**CITY OF NAPOLEON
BUILDING CONSTRUCTION PERMIT
(1, 2 or 3 Family Dwelling)**

| PROJECT | 12' X 28' Wood Frame Ratio Cover | | |

Addendum To Plan Approval

2 X 6 rafters 16" centers
4 X 4 Posts 7'
2 2 X 8 Beams

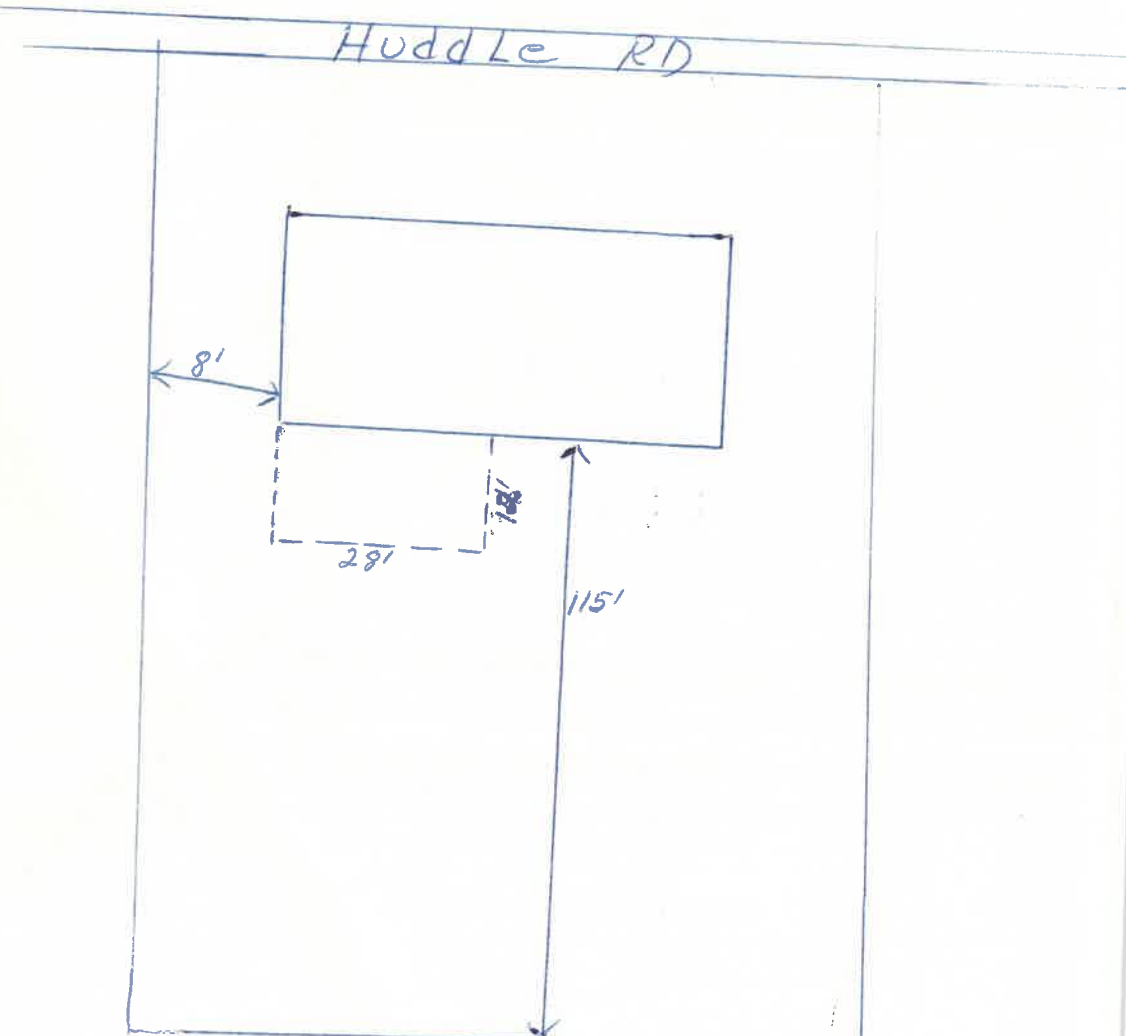
- 1) Because of span of girder you must provide a 4" X 4" post every 9'-4" o/c and use a double 2" X 6" for wood girder supporting the roof system. Table No. 4-B of B.C.A. Code.
- 2) Roof rafters max. span of 2' o/c for 2" X 6" rafters. Table No. 7-L
- 3) Provide a wood hanger or joist hangers under roof rafters to support roof system properly.

Completed as required. July 9/75
